SUBJECT: NuScale Power, LLC Supplemental Response to NRC Request for Additional Information No. 58 (eRAI No. 8835) on the NuScale Design Certification Application

Enclosure 1: NuScale Supplemental Response to NRC Request for Additional Information eRAI No. 8835

eRAI No.: 8835

NRC Question No.: 03.09.04-4

Figure 3.9-1: Reactor Module Showing Reactor Vessel Internals Component Assemblies

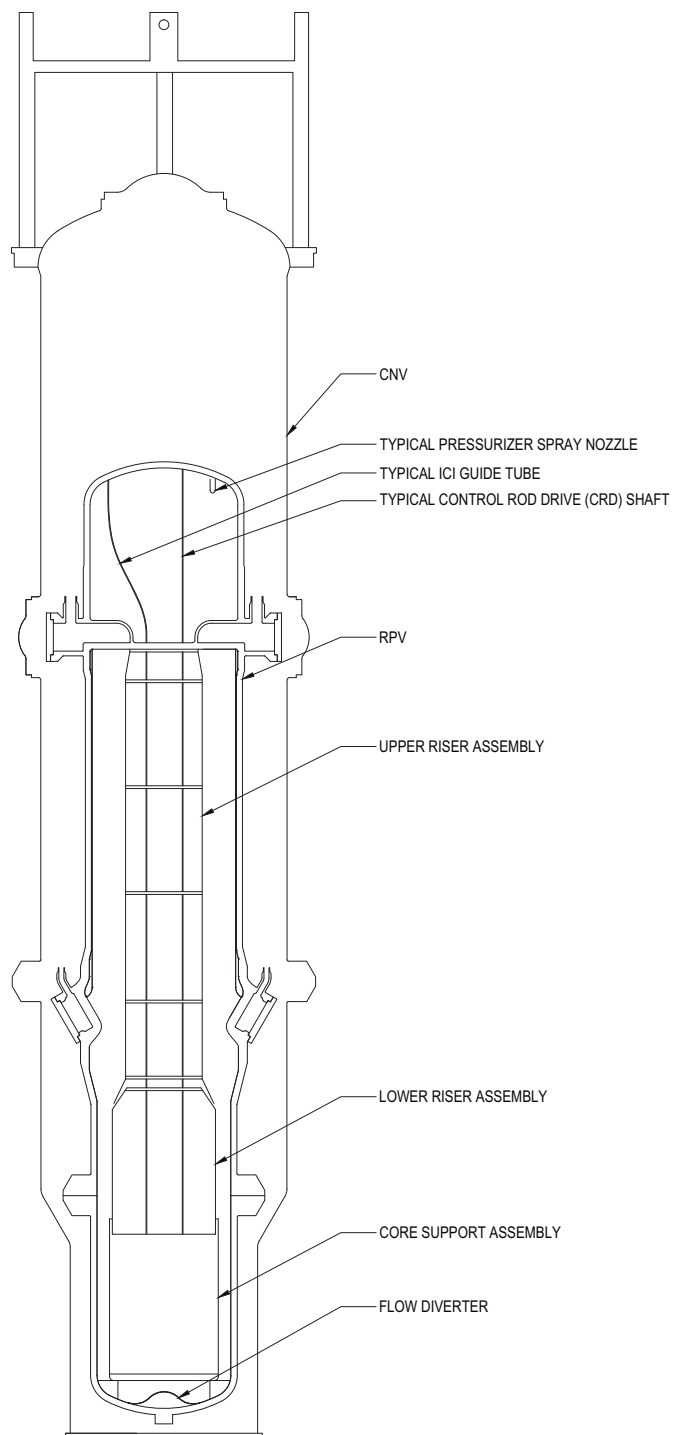
RAI 03.09.04-1S1, RAI 03.09.04-2S1, RAI 03.09.04-4S1

Figure 3.9-2: Upper Riser Assembly

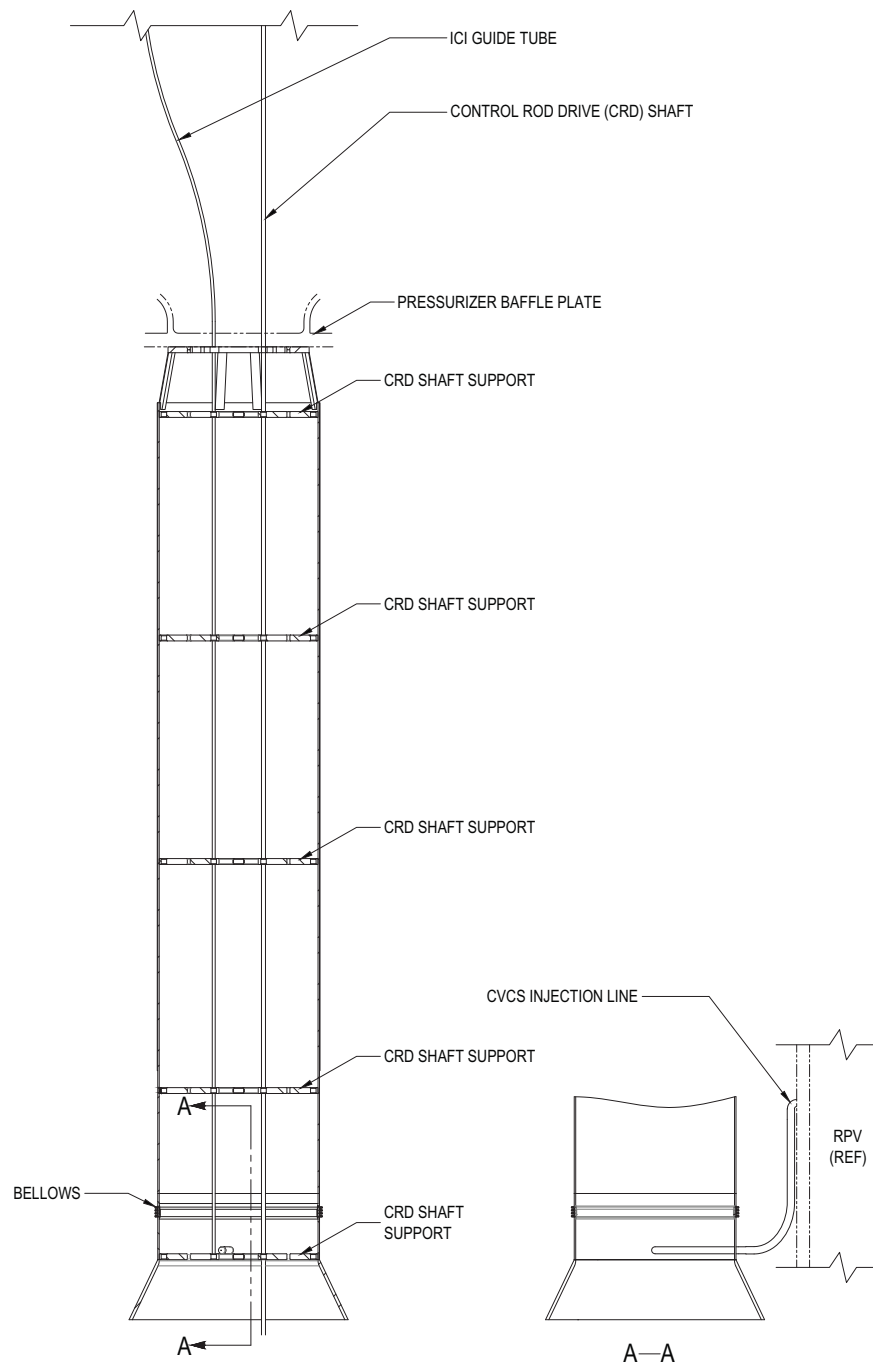
RAI 03.09.04-1S1, RAI 03.09.04-2S1, RAI 03.09.04-4S1

Figure 4.6-1: Overview of Control Rod Drive Mechanism Locations in Relation to the Reactor Pressure Vessel and Containment Vessel

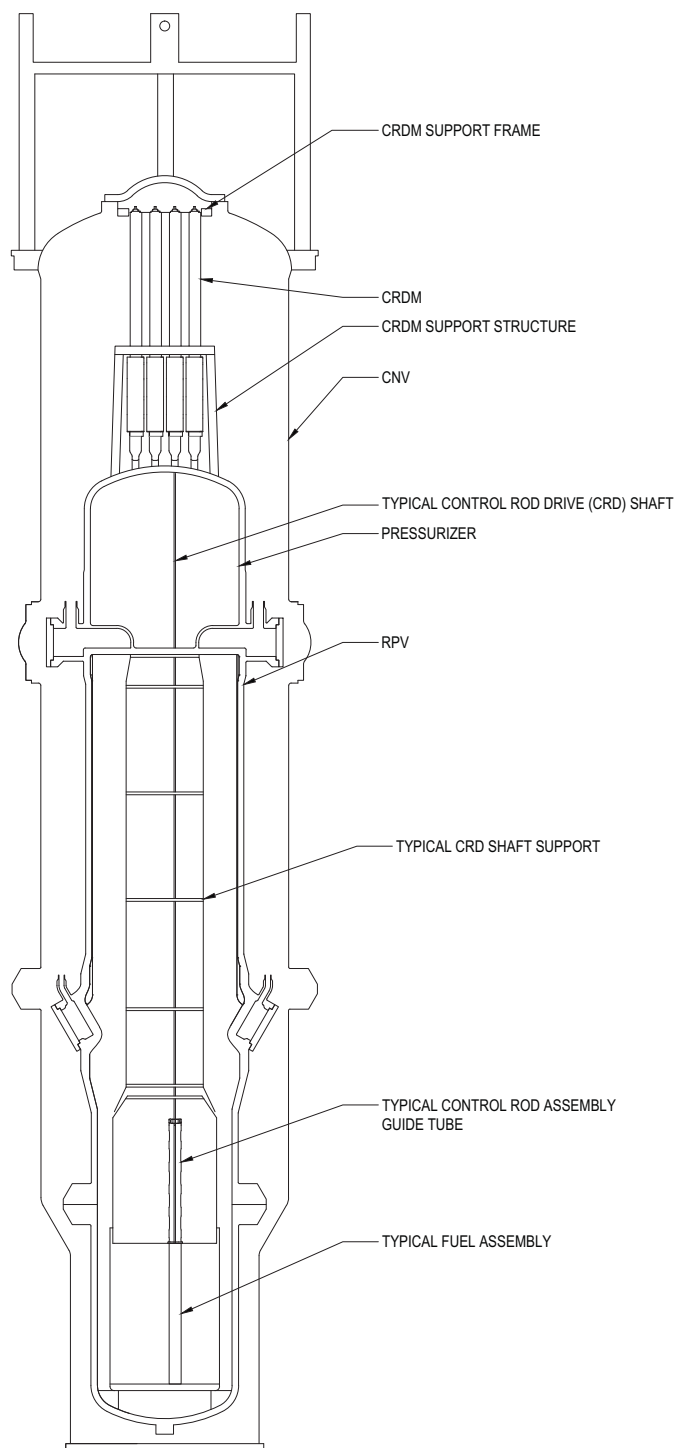
RAI 03.09.04-1S1, RAI 03.09.04-2S1, RAI 03.09.04-4S1

Figure 4.6-2: Control Rod Drive Mechanism Coils and Housings

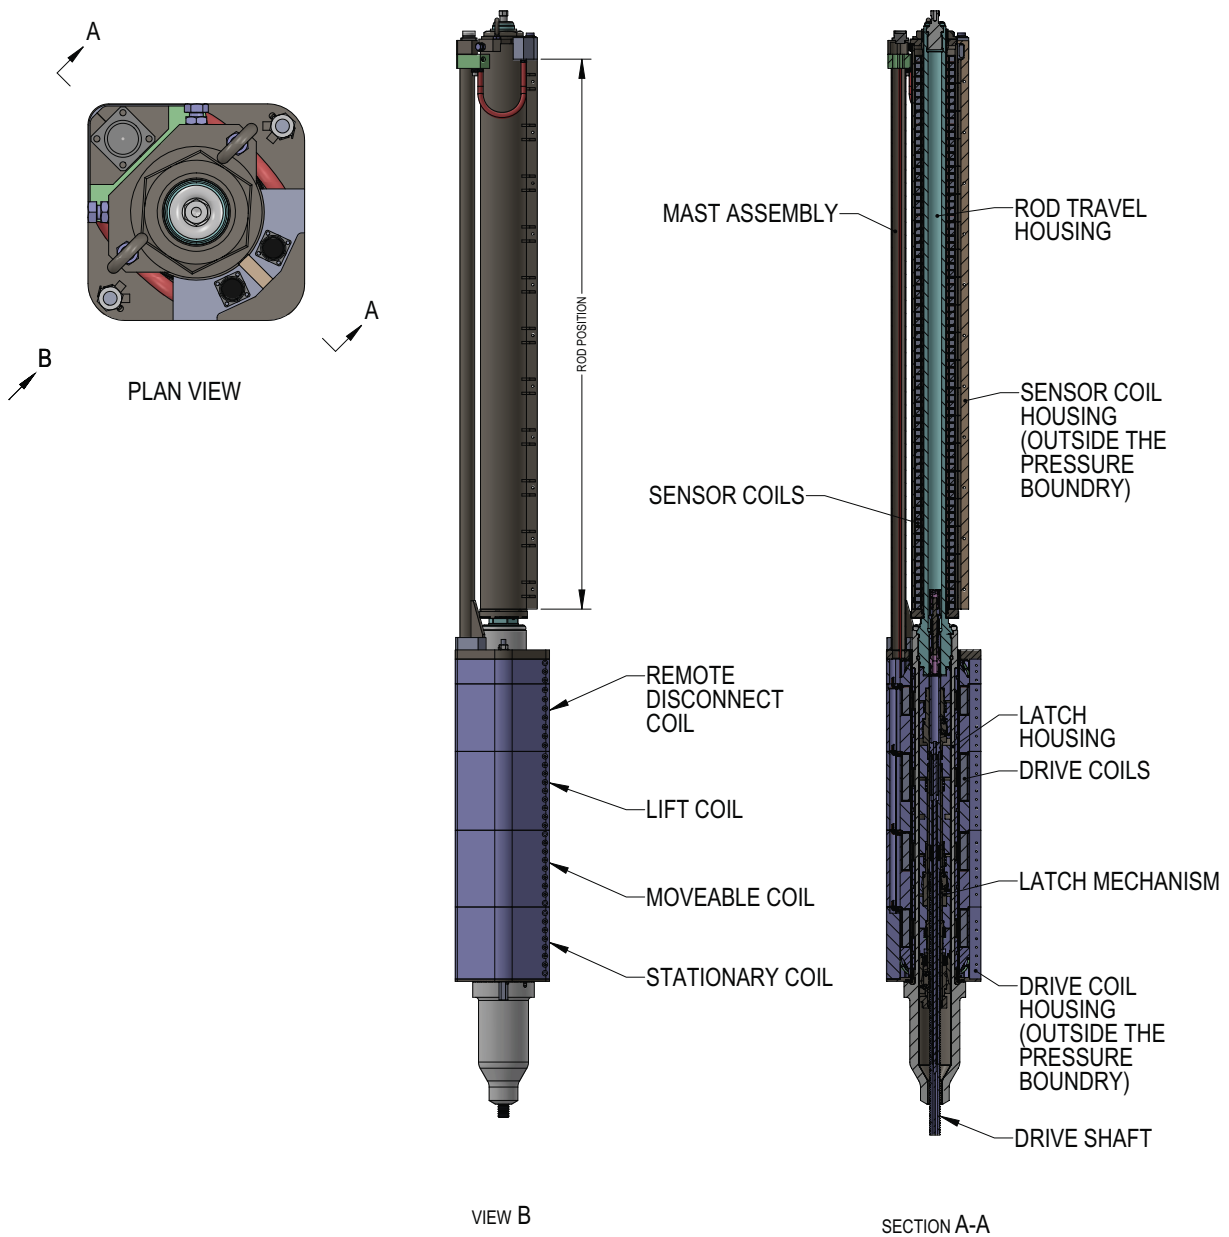
RAI 03.09.04-1S1, RAI 03.09.04-2S1, RAI 03.09.04-4S1

Figure 4.6-3: Control Rod Drive Mechanism Drive Coil and Cooling Detail

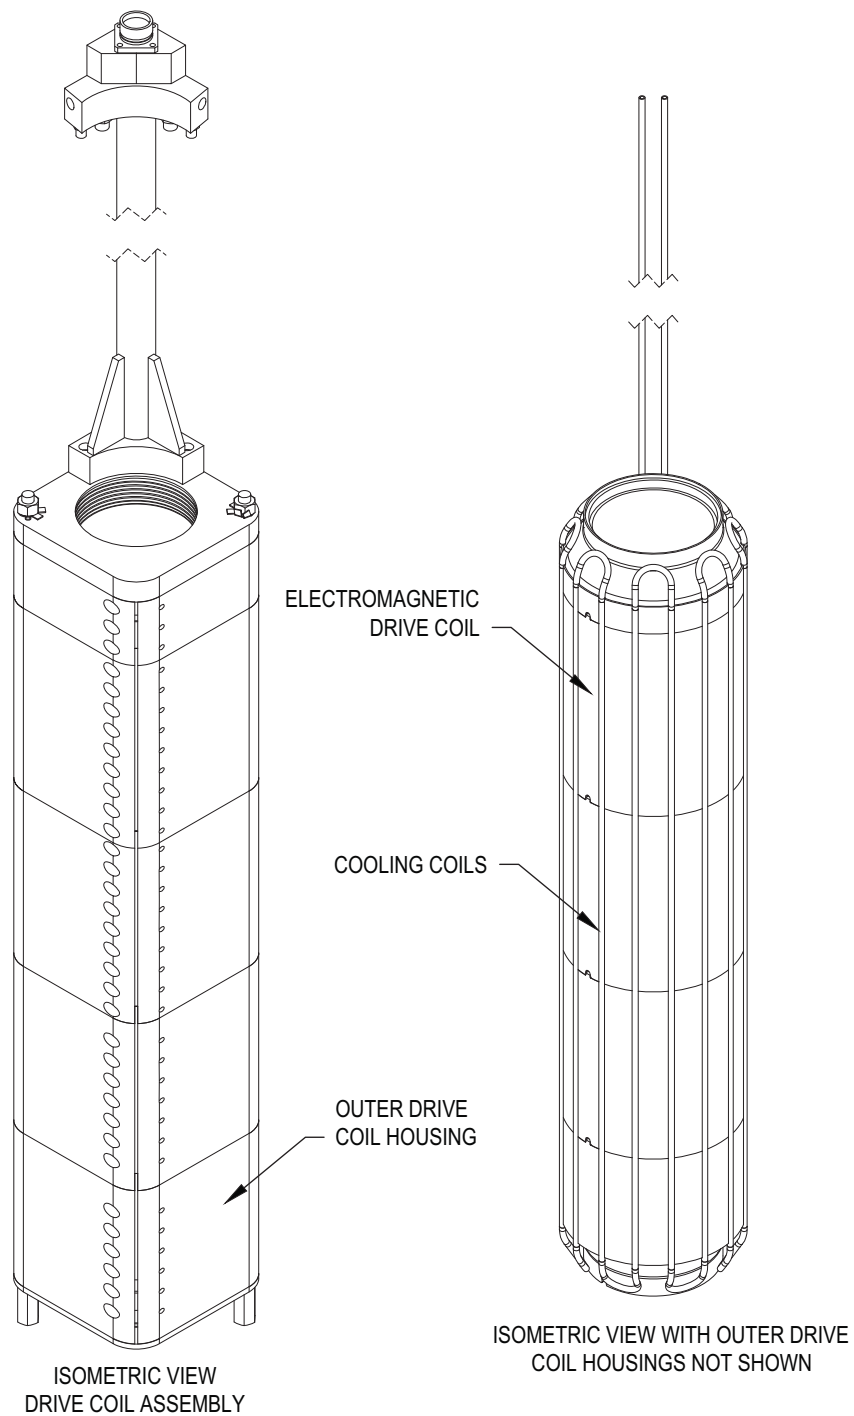
RAI 03.09.04-1S1, RAI 03.09.04-2S1, RAI 03.09.04-4S1
